**ADDENDUM NO. 5**

**ALTERATIONS & ADDITIONS TO:  
POLICE ANNEX TRAINING CENTER  
MARKET COMMON**

Myrtle Beach, South Carolina  
January 24, 2020

**1**  
**B4** **NEW LOW ROOF TO EXISTING**  
 SCALE: 3/8"=1'-0"

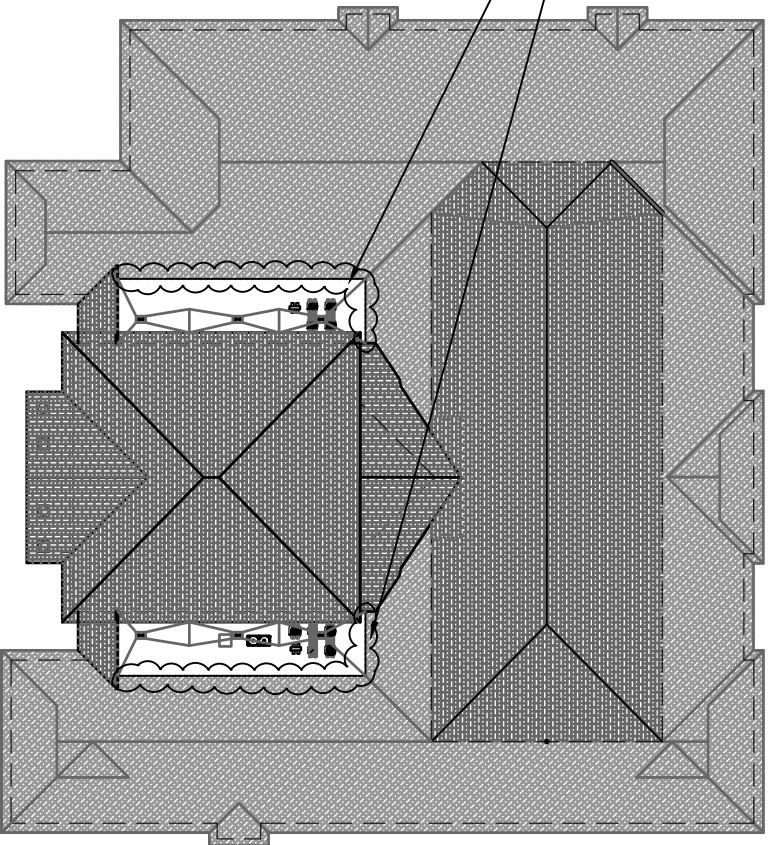
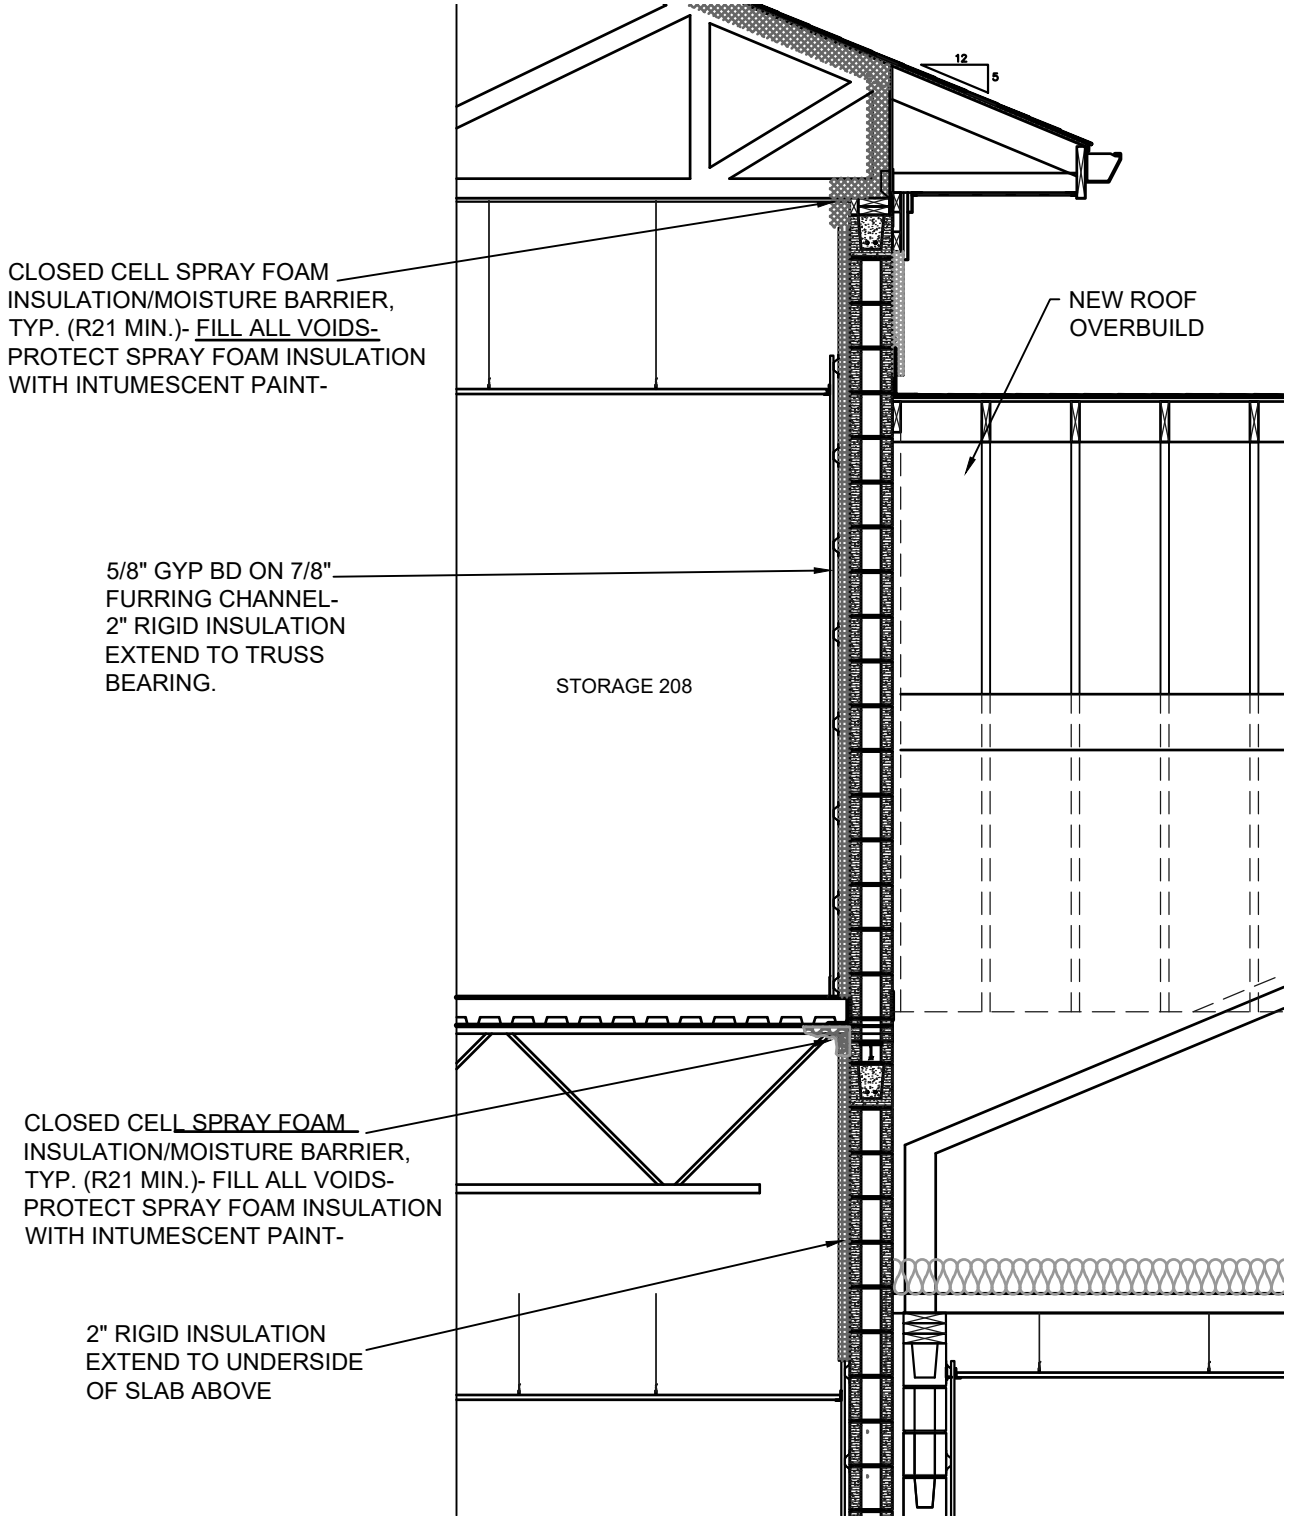
**Q9. THERE DOES NOT APPEAR TO BE A SPECIFICATION OR DESIGNATION ON THE DRAWINGS FOR INSULATING THE BACK WALL OF THE (2) STORY ADDITION, BELOW WHERE THE NEW ROOF SADDLE/OVERBUILD TIE OCCURS. THE BEST ILLUSTRATED IN DRAWING 1-A7.0. THE AREA OF EXISTING ROOF NEXT TO THE NEW (2) STORY BACK WALL IS RECEIVING (8) S.F. OF VENTING, MEANING THE SPACE ABOVE THE EXISTING CEILING IS INSULATED, WHILE VENTED AIR FLOWS THROUGH THE OLD FRAMING OF THE ROOF. THE INSIDE/FINISHED SIDE OF THE BLOCK WALL IS TO BE EXPOSED PAINTED CONCRETE BLOCK, WHILE THE OTHER SIDE IS OPEN AND EXPOSED TO THE ATTIC. SINCE WE ARE PUTTING OUTSIDE AIR CONDITIONS AGAINST THE BACK WALL, WHAT MEANS AND METHODS ARE WE TO USE TO INSULATE THAT AREA. THERE IS VERY LIMITED ACCESS TO THIS AREA AND IF THE VENT HOLES ARE CUT IN THE SHEETING OF THE OLD ROOF IN CONJUNCTION WITH THE NEW SADDLE/OVERBUILD, ACCESS TO THIS AREA IS EVEN MORE REMOTE.**

1. SHEET A7.0 – WALL SECTIONS and A7.1 – WALL SECTIONS
  - A. Contractor’s attention is directed to Detail 2/A7.0. Contractor is advised to revise per Bulletin Drawing B4 (attached herewith) consisting of 1 page dated 1/24/2020 for thermal barrier.

- B. Contractor’s attention is directed to Detail 1/A7.1. Contractor is advised to revise per Bulletin Drawing B4 (attached herewith) consisting of 1 page dated 1/24/2020 for thermal barrier.

A9. *Reference Bulletin Drawings B4 and B5 attached for clarification regarding providing a complete thermal barrier at locations indicated.*

CLOSED CELL SPRAY FOAM INSULATION/MOISTURE BARRIER, TYP. (R21 MIN.)- FILL ALL VOIDS- PROTECT SPRAY FOAM INSULATION WITH INTUMESCENT PAINT-TYPICAL AT LOCATIONS WHERE NEW LOW ROOF JOINS EXISTING ROOF  
 INTENT IS TO PROVIDE A COMPLETE THERMAL BARRIER AT EXISTING AND NEW CONSTRUCTION

**C5**

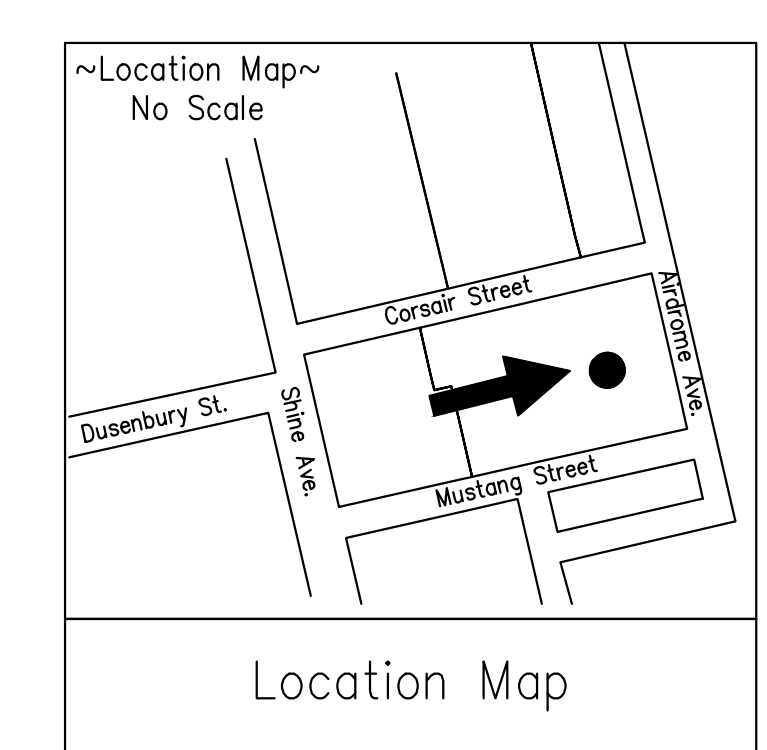
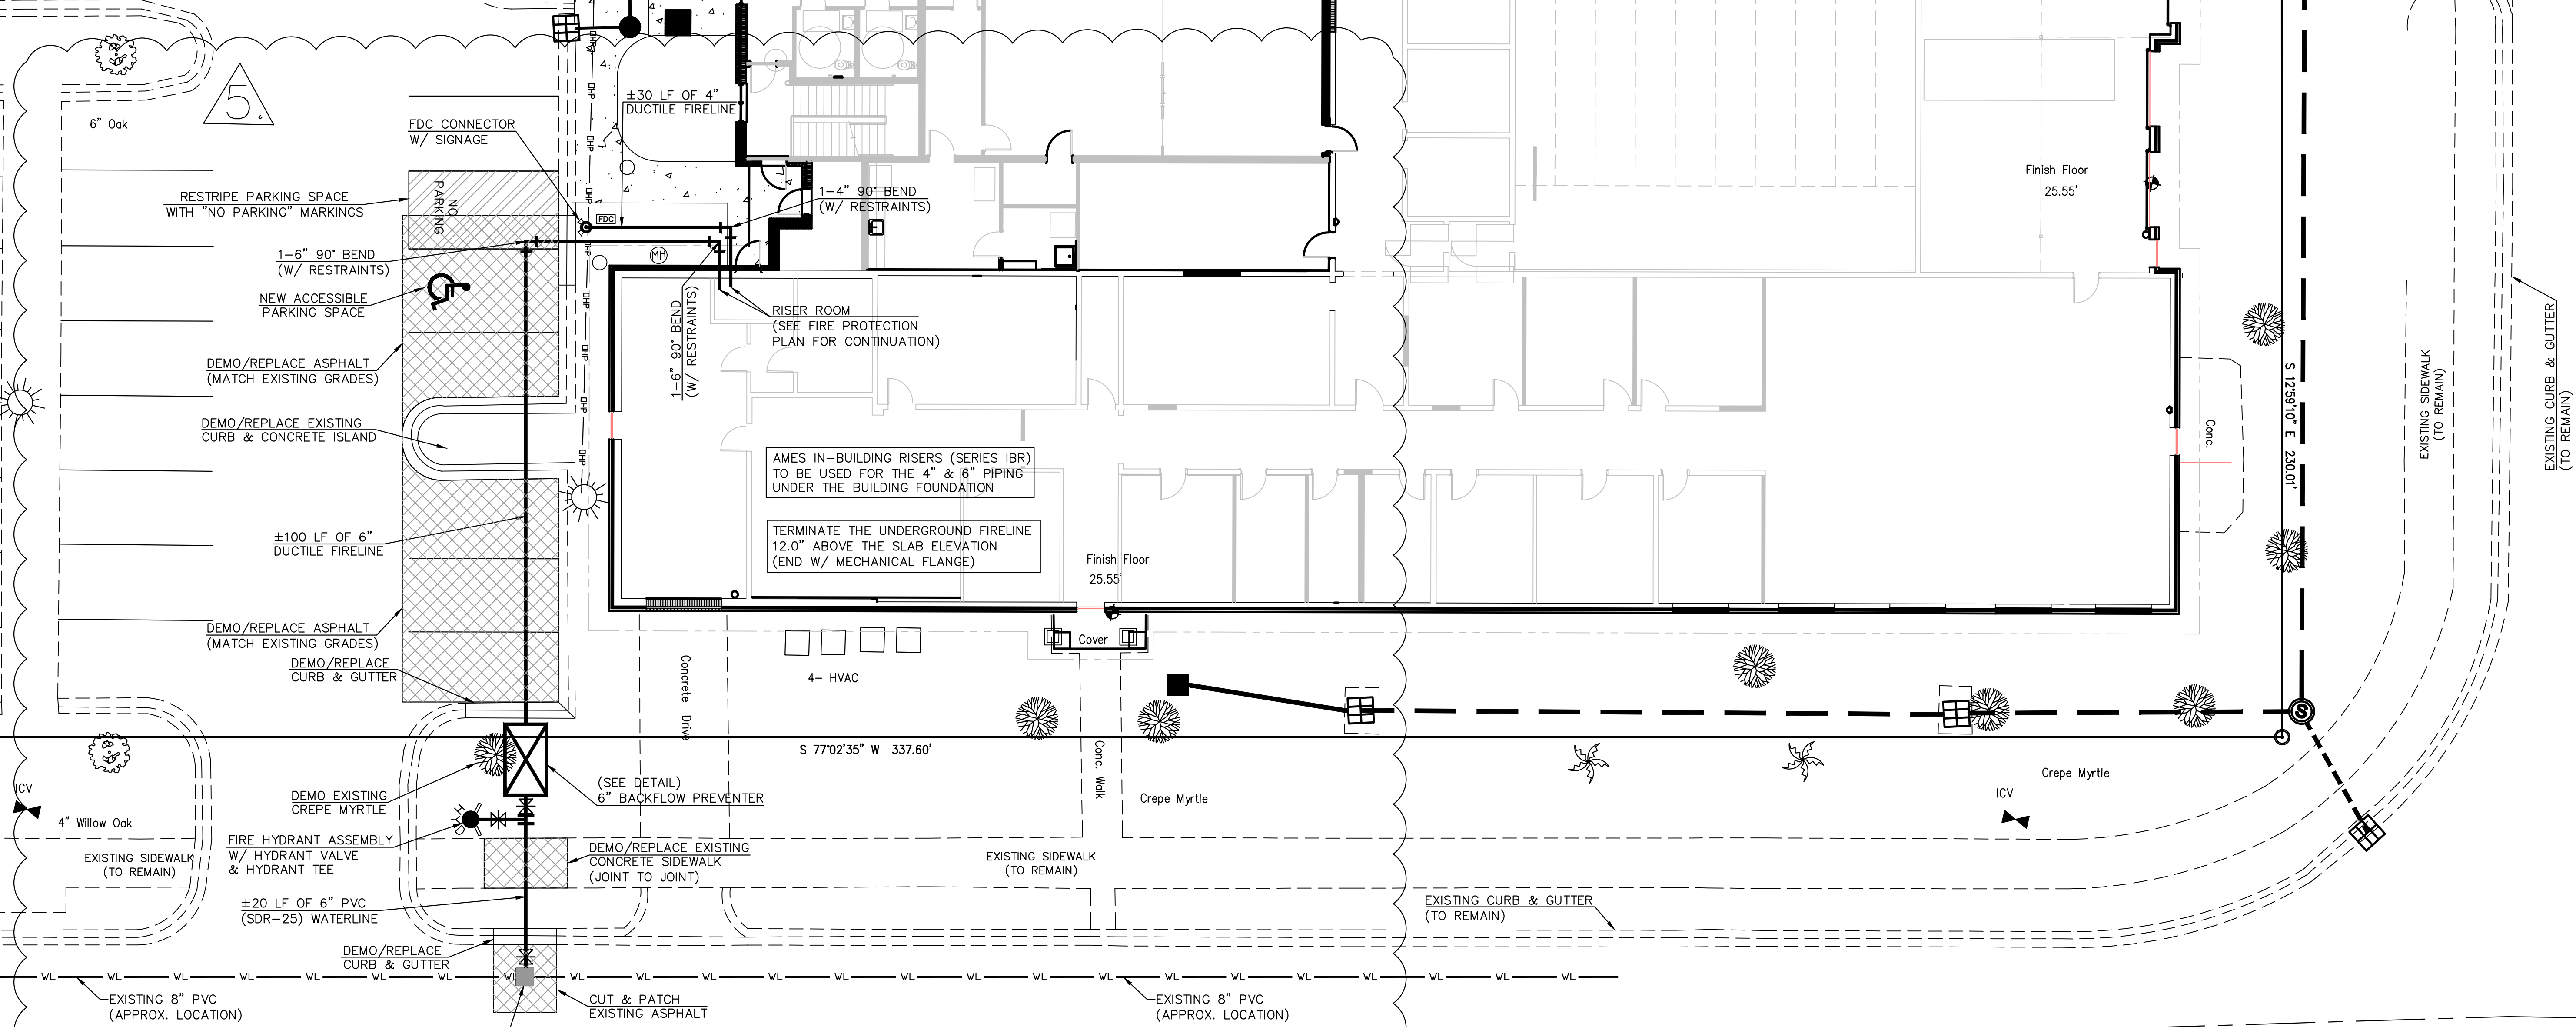
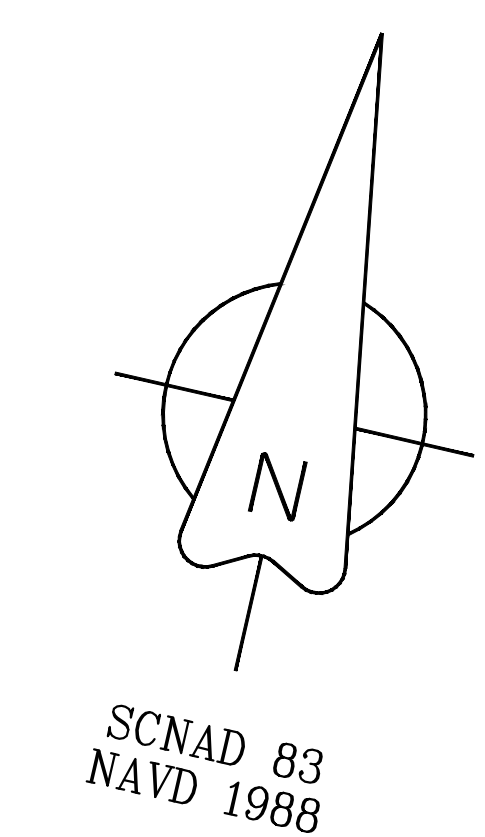
**Q11. AS PER DRAWING FP-1 OVERALL FLOOR PLAN – THE LOCATION OF THE “FDC”, IS CLEARLY MARKED, BUT AFTER THAT WE ARE NOT FINDING THE INFORMATION AS TO WHERE THE CONNECTION IS TO BE MADE FOR THE MAIN. THE NOTES READ “WATER SUPPLY FROM MAIN UTILITY, SEE CIVIL”, AS WELL AS “PIPING INSTALLED BY SITE CONTRACTOR, SEE CIVIL PLANS”. PLEASE ADVISE AS TO LOCATION OF PIPING AND BACKFLOW PREVENTOR/VAULT LOCATION.**

3. SHEET C5 – FIRELINE PLAN
  - A. Contractor’s attention is directed to SHEET C5 – FIRELINE PLAN. Contractor is advised to insert SHEET C5 – FIRELINE PLAN (attached herewith), consisting on 1 page and dated 1/24/2020.

- A11. *Add new 8" x 6" tap (to be coordinated with the City of Myrtle Beach). Add 25 LF of a 6" pvc waterline, 1 new fire hydrant and a 6" backflow preventer (WATTS 709DDC) in a concrete vault. Add 100 LF of ductile iron fireline. Add 4" ductile iron fireline and an FDC connection. AMES Riser to be used for the piping under the building. There will be minor demolition and replacing of asphalt and curbing in order to install the new fireline. See attached revised drawings C5 and C6.*
